# UNITED STATES PATENT AND TRADEMARK OFFICE

APPLICATION NO.	FILING DATE	FIRST NAMED INVENTOR	ATTORNEY DOCKET NO.	CONFIRMATION NO.
10/664,385	09/17/2003	Lewis George Gradon	1171/41403	4417

<b>Office Action Summary</b>	<b>Application No.</b> 10/664,385	<b>Applicant(s)</b> GRADON ET AL.	
	<b>Examiner</b> Amadeus S. Lopez	<b>Art Unit</b> 3771

## **DETAILED ACTION**

Fig. 1

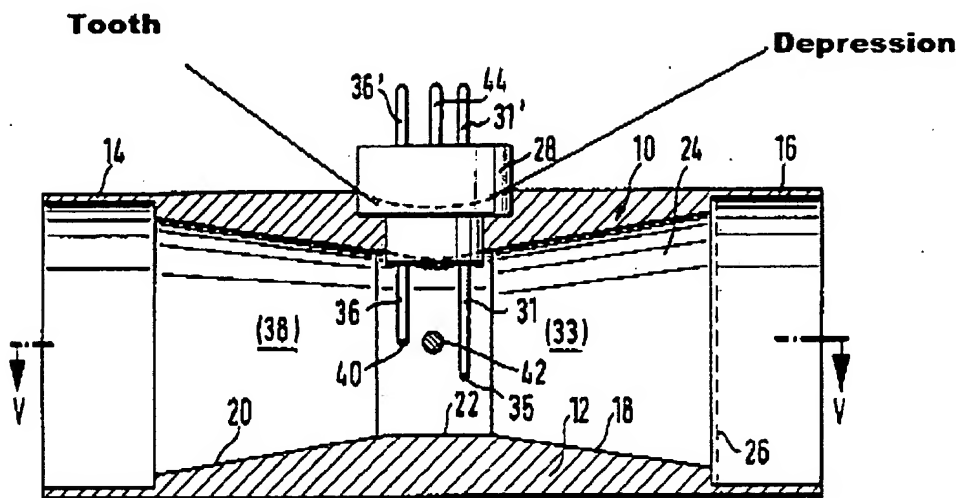
and depression as labeled in the figure 1 provided in the prior office action still read on the claims. The tooth is reasonably interpreted to be an extension from the body of the sensor, which in this case is the larger cylindrical portion of the body of the sensor that fits within the depression provided in the breathing conduit. The applicant has not provided any particular definition or structural limitations of the "tooth" and "depression" in the claims to warrant a withdrawal of the rejection, because as it stands, William still discloses a tooth and depression that anticipates the breathing circuit component of claim 1 and 14. Therefore, the rejections as set forth in the office action filed on 6/05/2006 with regards to the William reference stand and are hereby repeated.

**2. With regards to claim 1**, what is taught and shown by William in Fig. 1 below is a breathing circuit component or connector having an interior for conveying respiratory gas comprising: a sensor entry port (crossbore passage leading into interior of conduit; Col. 2, lines 61-66) configured to receive a sensor (28; contains sensing elements 34, 35, and 40), and a locating depression (labeled in diagram below as the dotted line portion marking the depression from the outer surface of the conduit) configured to receive a complementary locating tooth (labeled below; examiner is using a reasonable broad interpretation of the word tooth to be an extension from the body of the sensor which in this case is the larger cylindrical portion of the body of the sensor that fits in the depression) from a sensor, the interconnection of said depression and a tooth providing a predetermined orientation of a sensor within said interior.

5. **With regards to claim 16**, what is taught and shown by William in Figs. 1-3 is a breathing circuit component wherein said locating depression comprises a notch (labeled in Fig. 1 above as the dotted line portion marking the depression or notch from the outer surface of the conduit) in the end of said cylinder distant said interior.

7. **With regards to claim 17**, what is taught and shown by William in Fig. 1-3 is a breathing circuit component with all the limitations of claim 16 as rejected above and 17 with the exception of the notch being substantially "V" shaped. What is taught and shown by William in Fig. 1 is a depression that is substantially "U" shaped. After reviewing the specification, the examiner has concluded that at no point in the disclosure does the applicant establish any criticality for utilizing a "V" shaped notch. Therefore it would have been an obvious matter of design choice to one of ordinary skill in the art at the time the invention was made to have a notch that is V, U or any other shape that would be effective in locking two separate pieces together.

8. **With regards to claim 18**, what is taught and shown by William in Fig. 1-3 is a breathing circuit component wherein a base, or bottom portion of the notch prior to the interior conduit, of the notch is rounded (Fig. 1).

airtight seal against a sensor located therein (From Fig. 1 it is shown by William that the sensor body completely occludes the passage formed by the crossbore leading into the hollow conduit.

wherein the gas outlet includes an inner surface (Fig. 1 shows tapered interior surface) configured to form a substantially airtight seal against an exterior surface of a conduit.

13. **With regards to claim 23**, what is taught and shown by William in Fig. 1-3 is a breathing circuit component further comprising a flow sensor (28) having a substantially cylindrical exterior (Fig. 1) configured to form an airtight seal against said passage (crossbore passage leading into hollow interior of conduit), a sensing end (40 and 35) and a locating tooth (labeled in Fig. 1 above; examiner is using a reasonable broad interpretation of the word tooth to be an extension from the body of the sensor which in this case is the larger cylindrical portion of the body of the sensor that fits in the

depression) to mate with said locating depression (labeled in Fig. 1 above as the dotted line portion marking the depression from the outer surface of the conduit) and locate said sensing end in predetermined location or orientation within said interior.

14. **With regards to claim 24**, what is taught and shown by William in Fig. 1-3 is a breathing circuit component with all the limitations of claim 23 as rejected above and 24 with the exception of the notch being substantially "V" shaped. What is taught and shown by William in Fig. 1 is a depression that is substantially "U" shaped. After reviewing the specification, the examiner has concluded that at no point in the disclosure does the applicant establish any criticality for utilizing a "V" shaped notch. Therefore it would have been an obvious matter of design choice to one of ordinary skill in the art at the time the invention was made to have a notch that is V, U or any other shape that would be effective in locking two separate pieces together.

15. **With regards to claim 25**, what is taught and shown by William in Fig. 1-3 is a breathing circuit component wherein a base, or bottom portion of the notch prior to the hollow interior conduit, of the notch is rounded (Fig. 1).
